Wisconsin Department of Transportation

Proposal #23: 6170-00-61
C Wautoma, S Cambridge St
STH 22 S to STH 22 N
STH 21
Waushara County

6310-00-60, WISC 2021 180
Princeton - Plainfield
STH 22 S to CTH BB
STH 73
Waushara County

This is Addendum No. 02, which provides for the following:

Addendum No. 02
 ID 6310-00-60
 Revised Sheet 33
 February 3, 2021

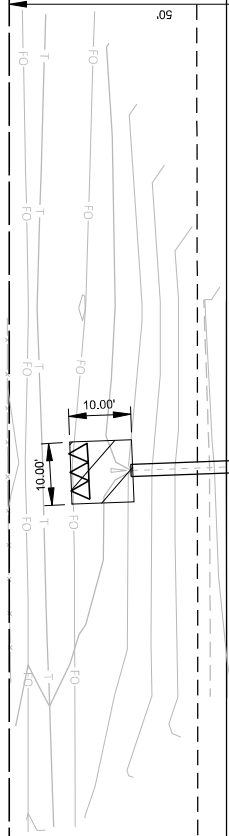
EXISTING 1'-24" x 50" CP RC
 INV. 1104.12
 PIPE SLOPE = 1.14%
 O/FULL EX = 26.2 CFS
 INSTALL 24" CLASS III-B CULVERT PIPE
 AND APRON ENDWALLS
 UPSTREAM INV. 1104.12
 DOWNSTREAM INV. 1103.26

Addendum No. 02
 ID 6310-00-60
 Revised Sheet 69
 February 3, 2021

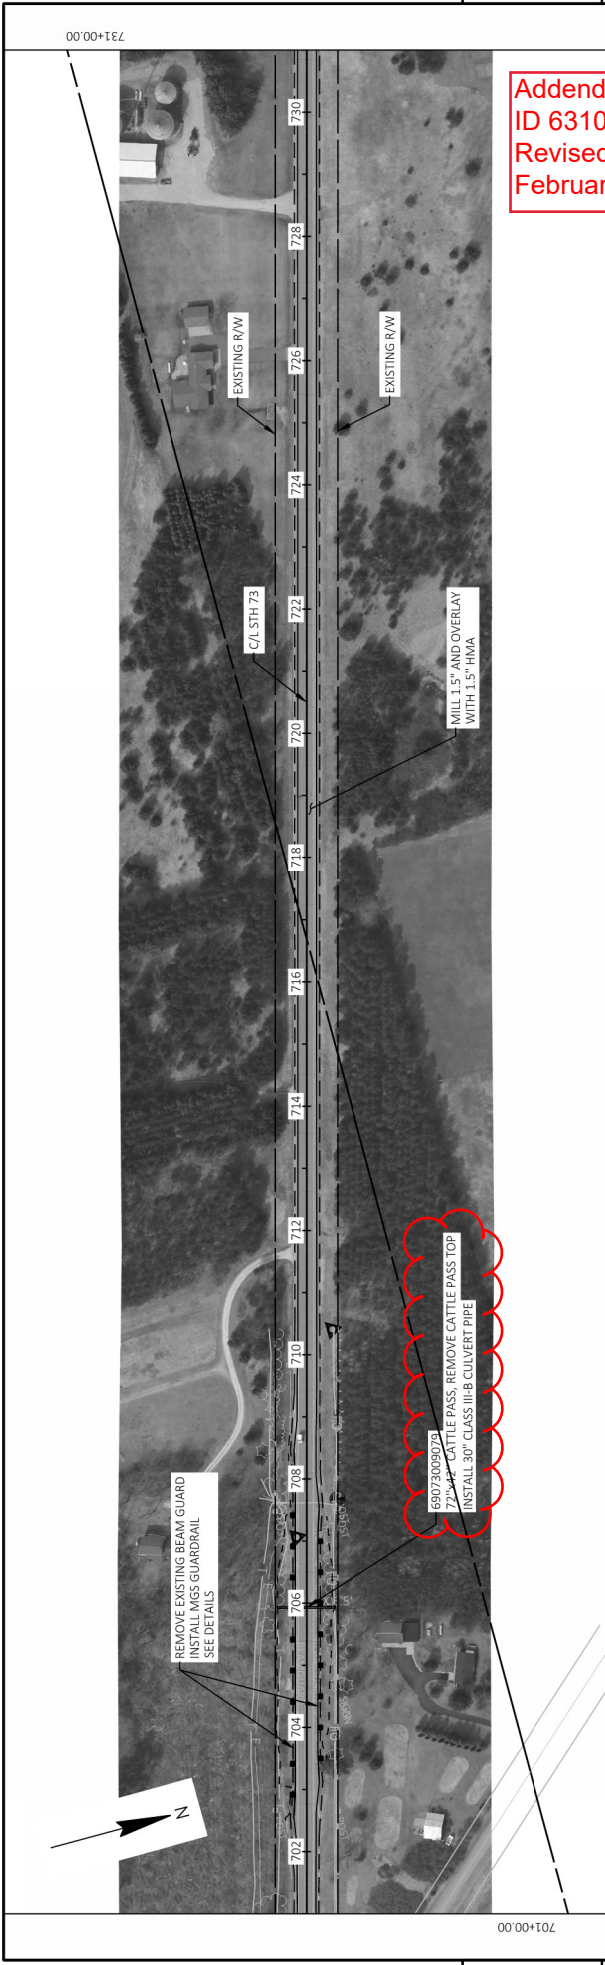
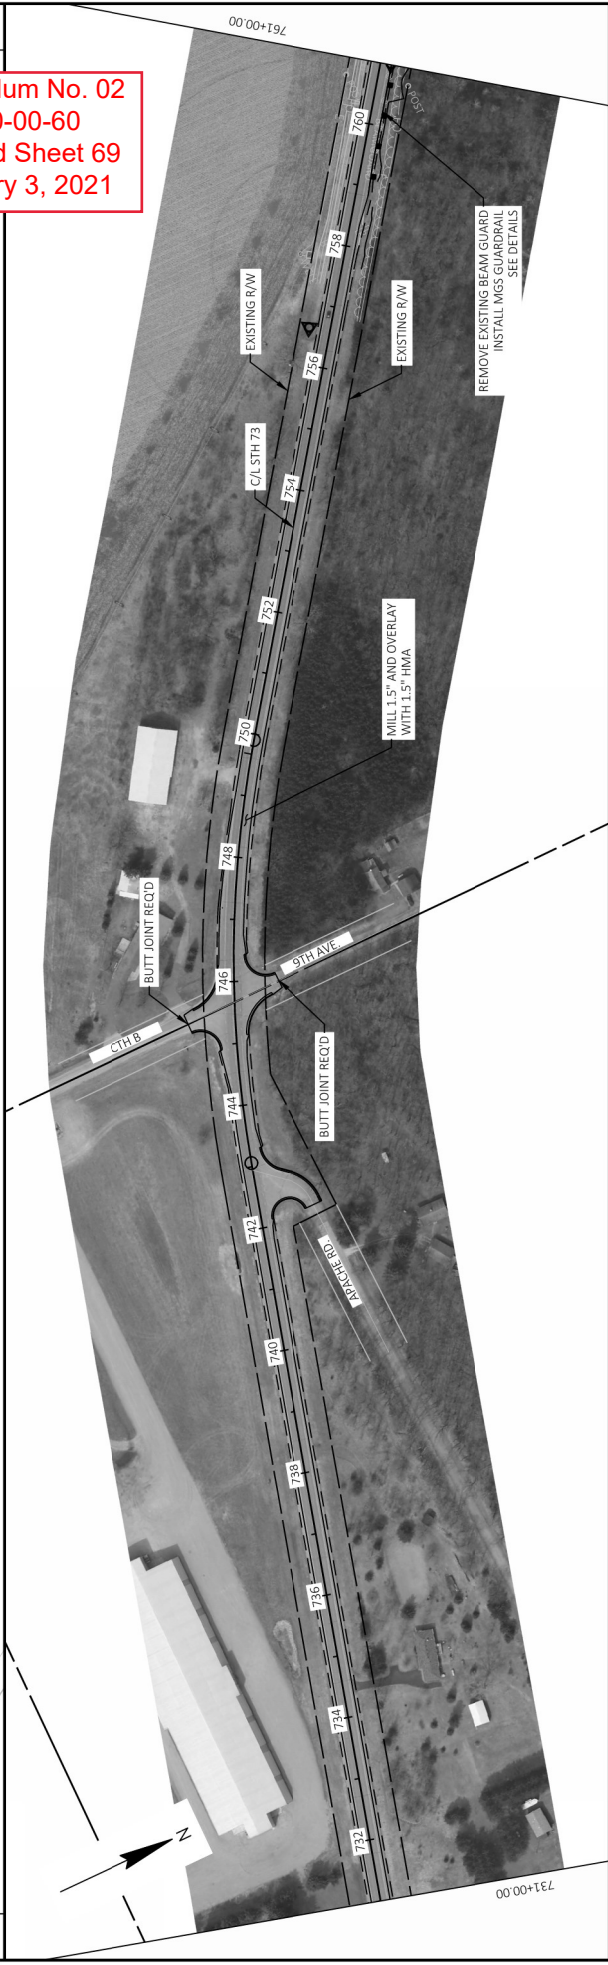
Revised Plan Sheets – 6310-00-60	
Plan Sheet	Plan Sheet Title (brief description of changes to sheet)
26	Removed Liner Size, Revised Existing Q(full)
27	Removed Liner Size, Revised Existing Q(full)
28	Removed Liner Size, Revised Existing Q(full)
29	Removed Liner Size, Revised Existing Q(full)
30	Removed Liner Size, Revised Existing Q(full)
31	Item Change for Pipe Culverts
32	Item Change for Pipe Culverts
33	Item Change for Pipe Culverts
34	Removed Liner Size, Revised Existing Q(full)
50	Item Revisions in Miscellaneous Quantities for Pipe Culverts
55	Added Item of Slope Staking in Miscellaneous Quantities
66	Item Change for Pipe Culverts
69	Item Change for Pipe Culverts
70	Item Change for Pipe Culverts

69073009075
 724' CATTLE PASS, REMOVE CATTLE PASS TOP
 INSTALL 30" CLASS III-B CULVERT PIPE
